STATE OF NORTH CAROLINA  
DEPARTMENT OF TRANSPORTATION

Subject: **Response to US Army Corps of Engineers Letter** for the proposed NC 133 Connector from NC 211-133 (Southport Supply Road) to NC 87-133 (River Road), Brunswick County, TIP R-3324.

References: Application for an Individual Section 401 Water Quality Certification dated July 19, 2012  
USACE Request for Additional Information Letter dated, September 18, 2012 (received September 24, 2012).  
NCDOT Response to US Army Corps of Engineers Letter dated, October 18, 2012.

# SITE VI

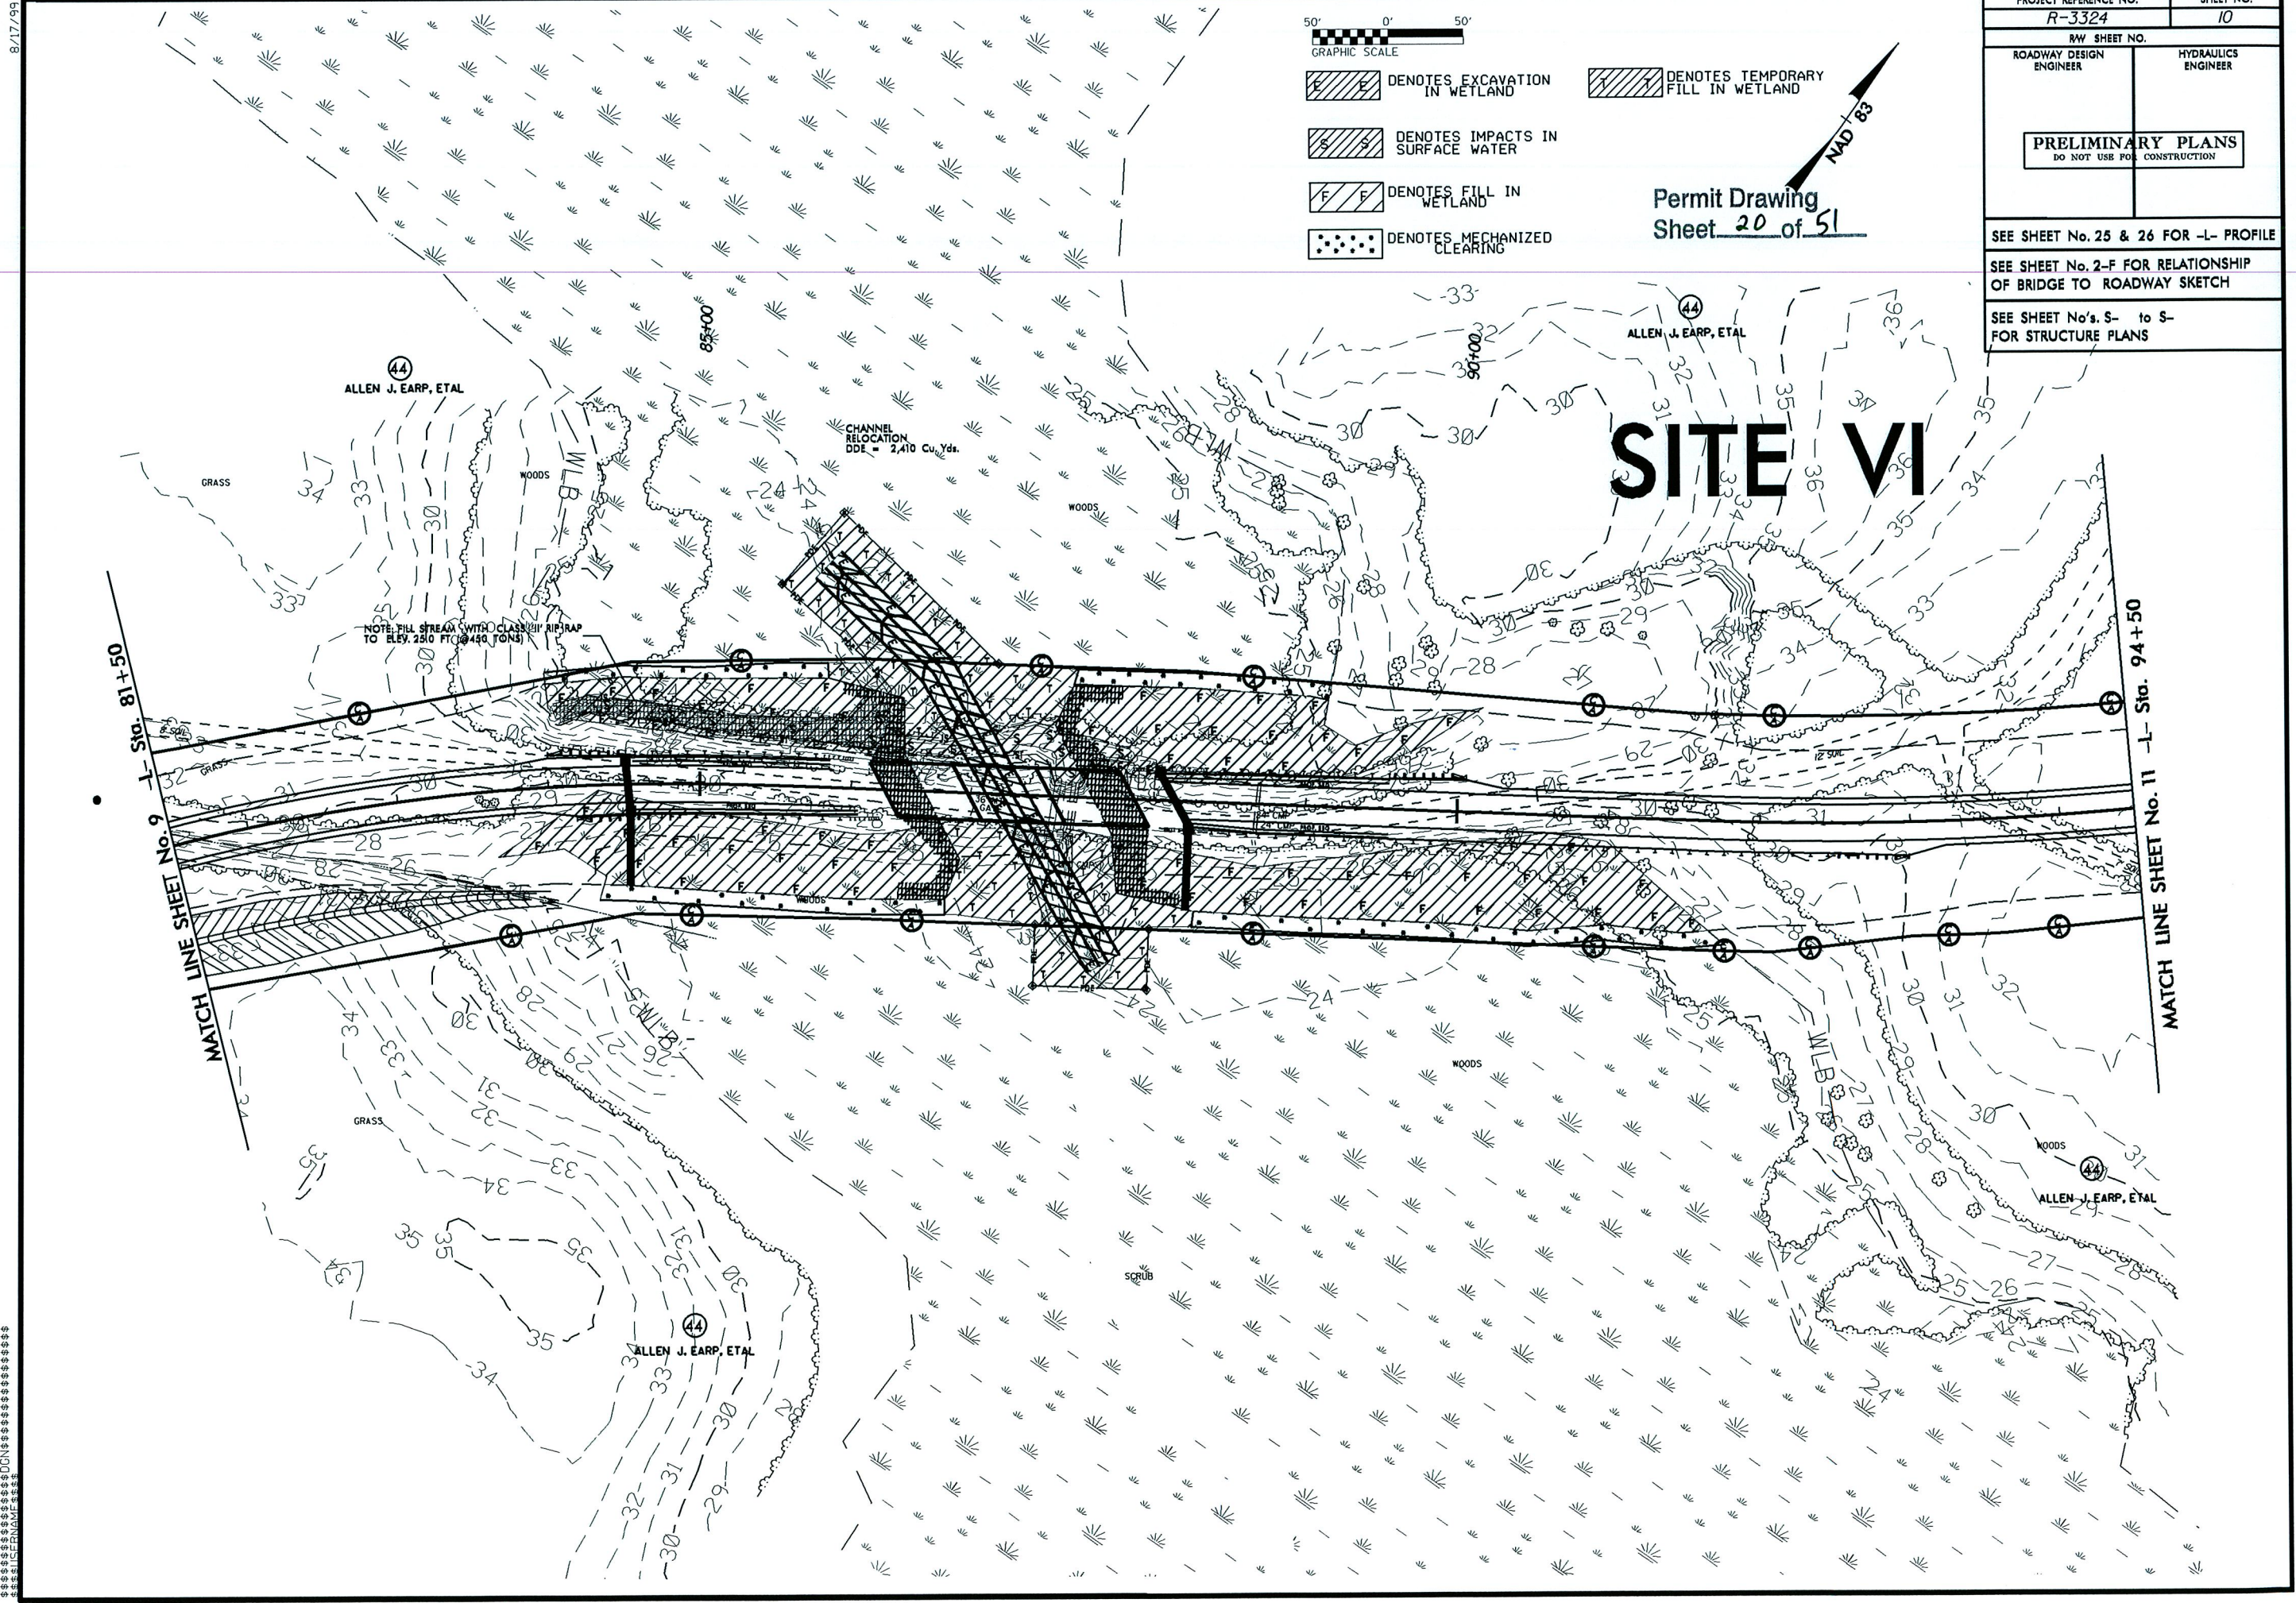
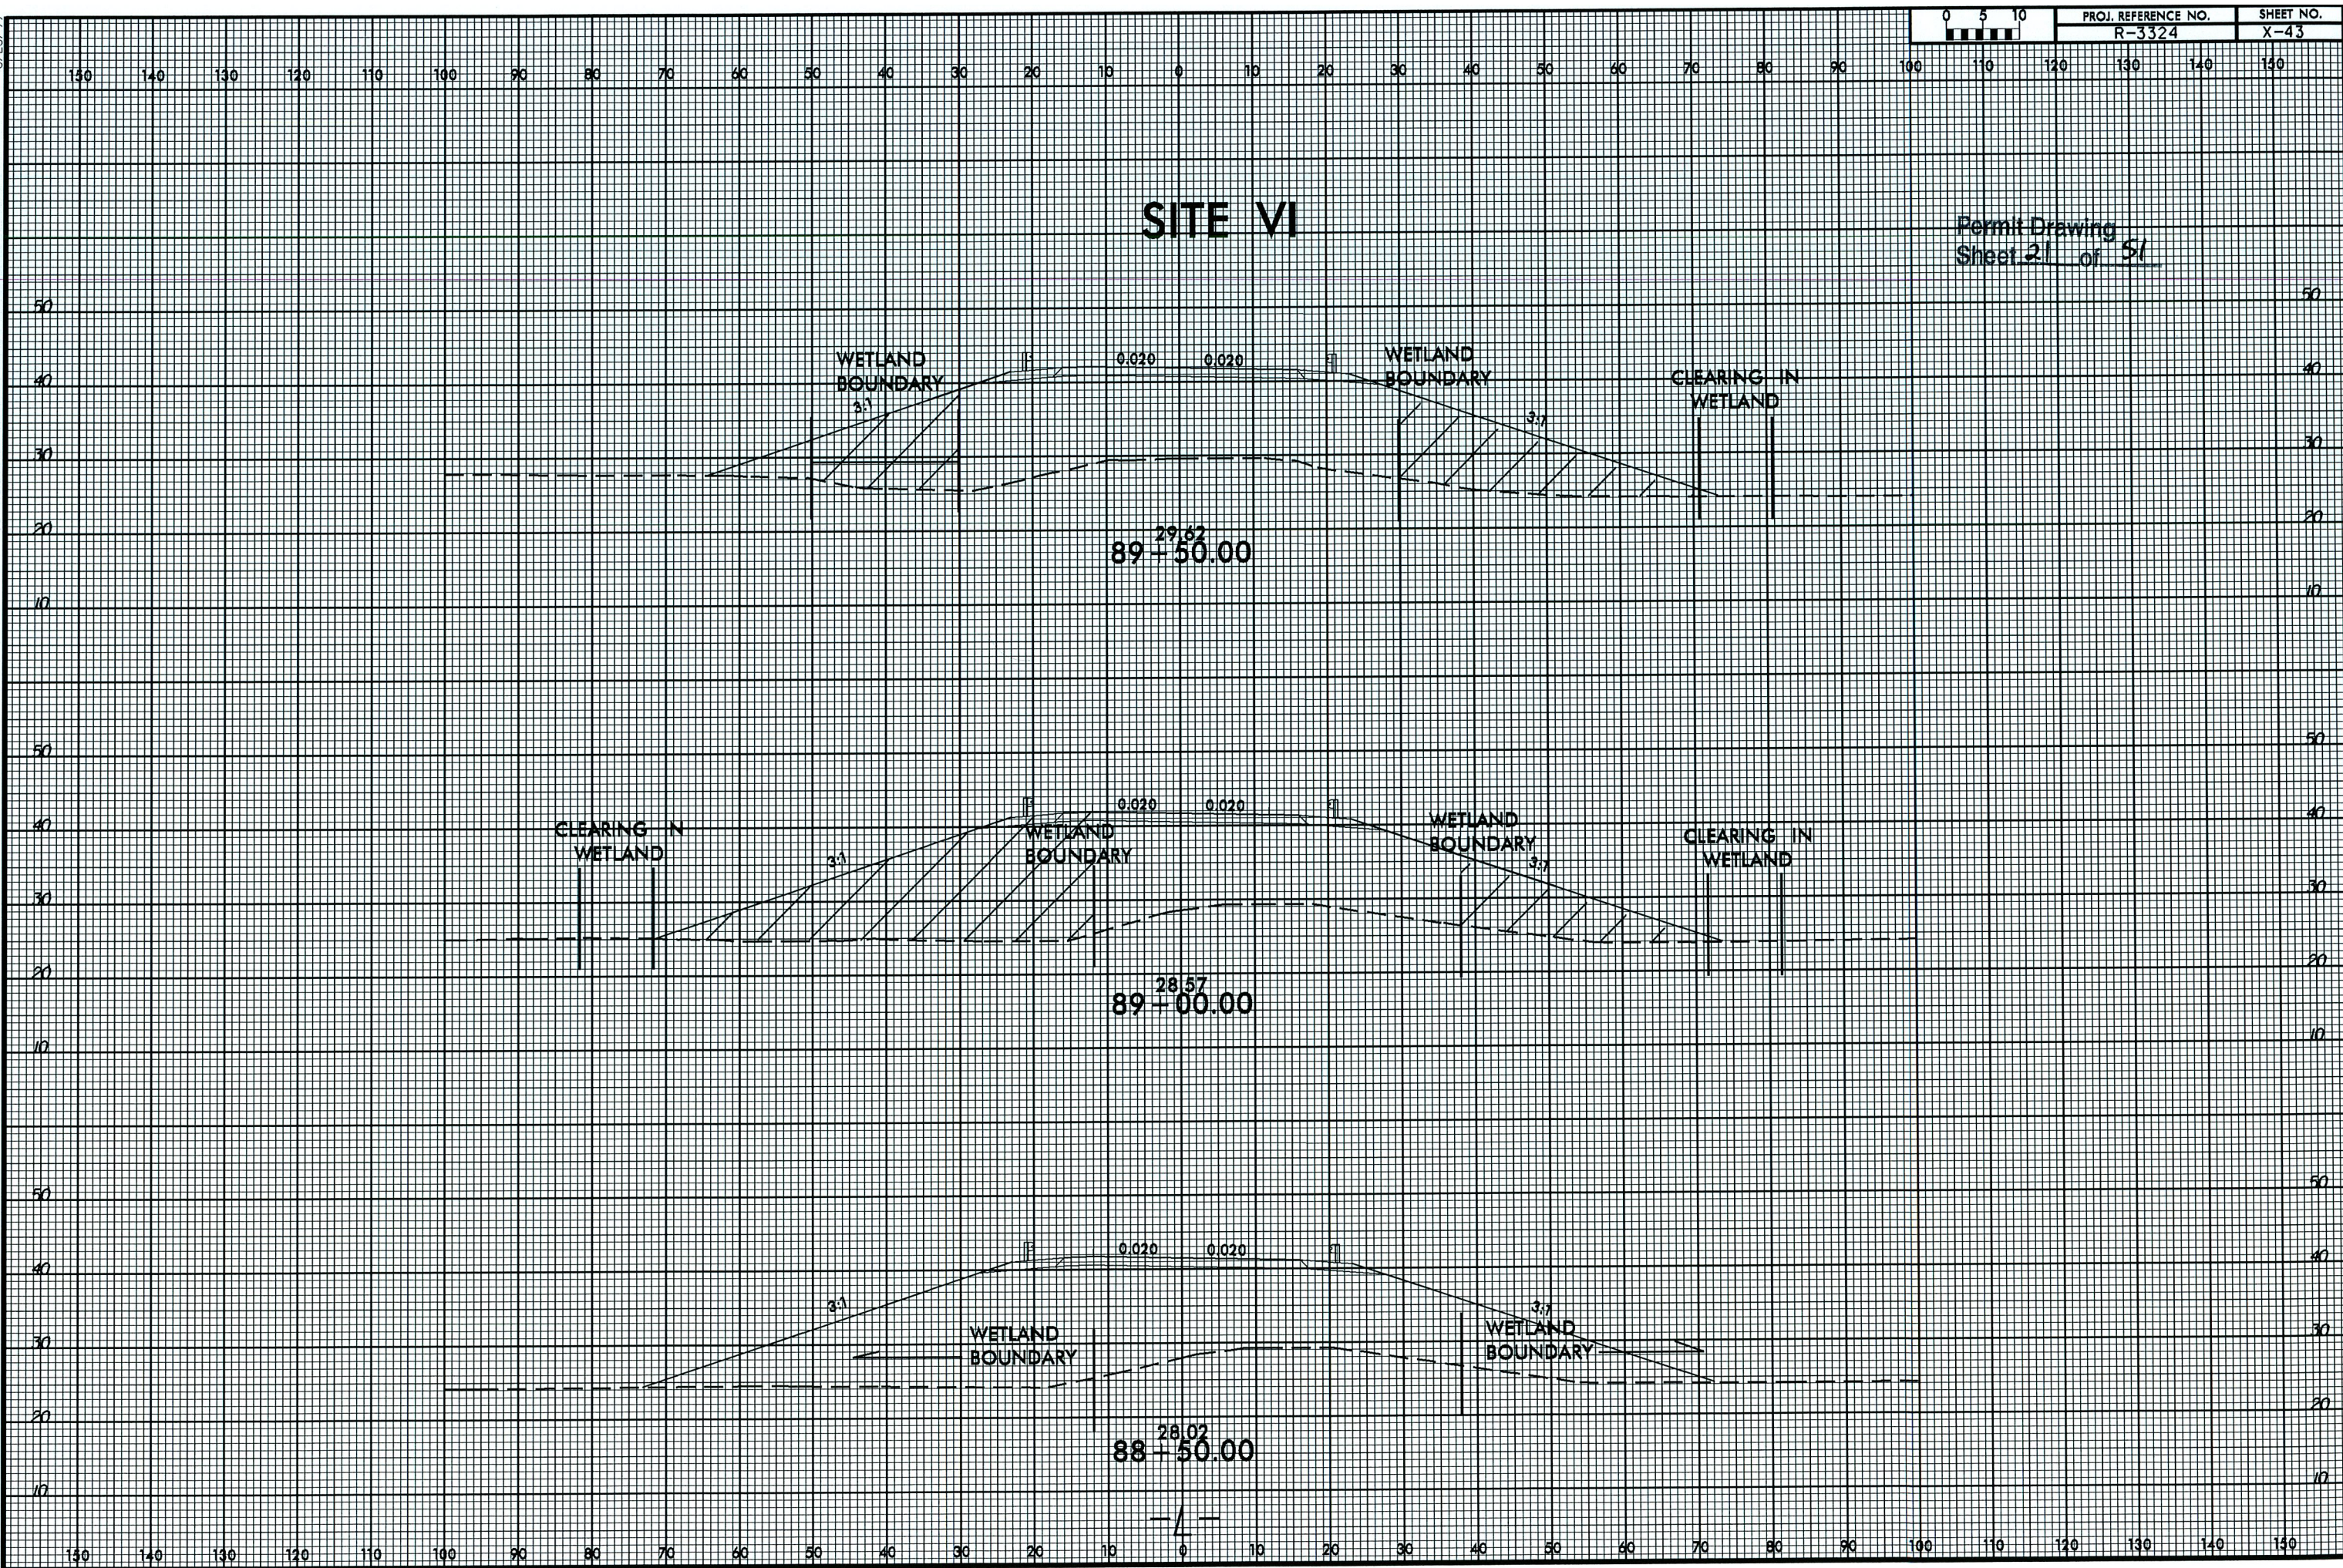
5. Site 6: *Will dewatering be necessary for installation of 48" pipe into tail ditch along WD?*

There will be no need for dewatering at Site 6. The new pipe and channel can be installed in the dry and then have the water turned through them.

# SITE VII

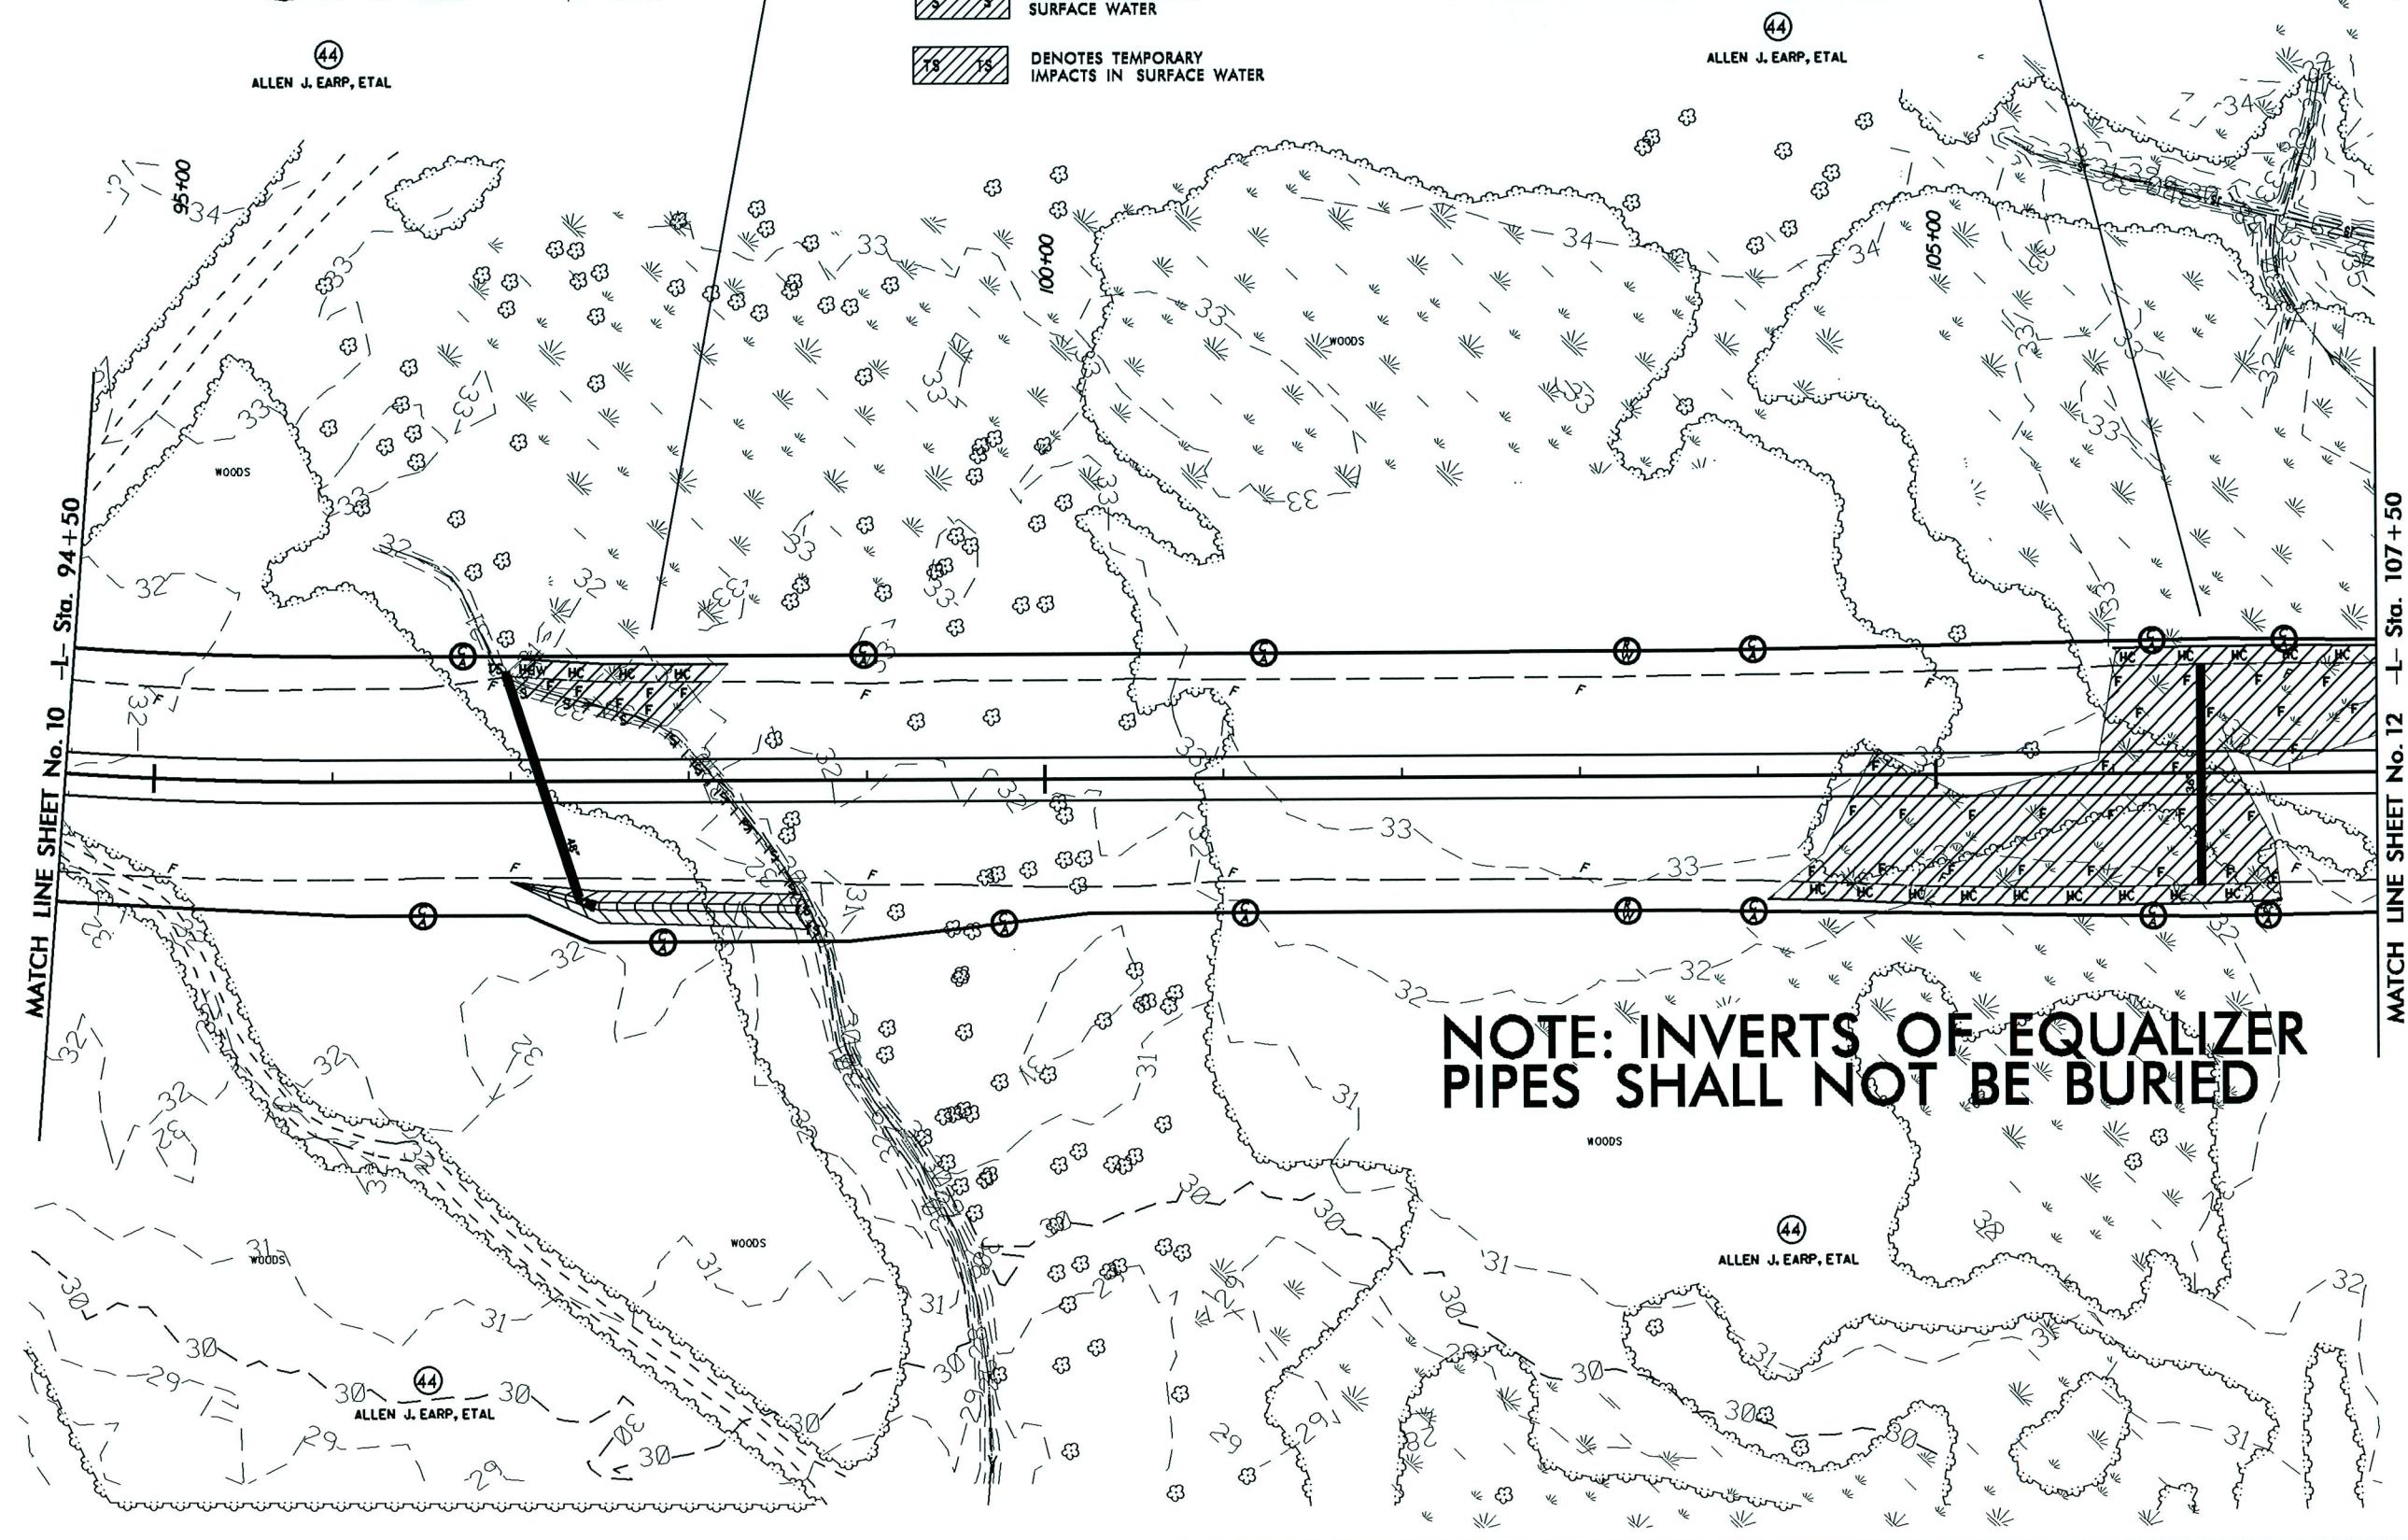
6. Site 7: *Will dewatering be necessary for installation of 48" pipe?*

There will be no need for dewatering at Site 7. The new pipe and channel can be installed in the dry and then have the water turned through them.
